Product Change Notice

3M™ Static Shielding and Moisture Barrier Bags

Issue Number: 882
Date: May 30, 2014

Example of format change (Static Shielding Bag)

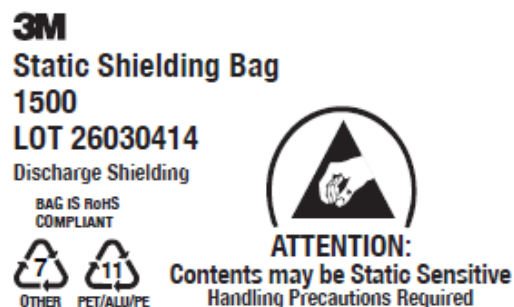
The change to the hot-stamp image is being made to reflect corporate guidelines for formatting and content, using the correct PN, and adding the EIA reference “Discharge Shielding.”
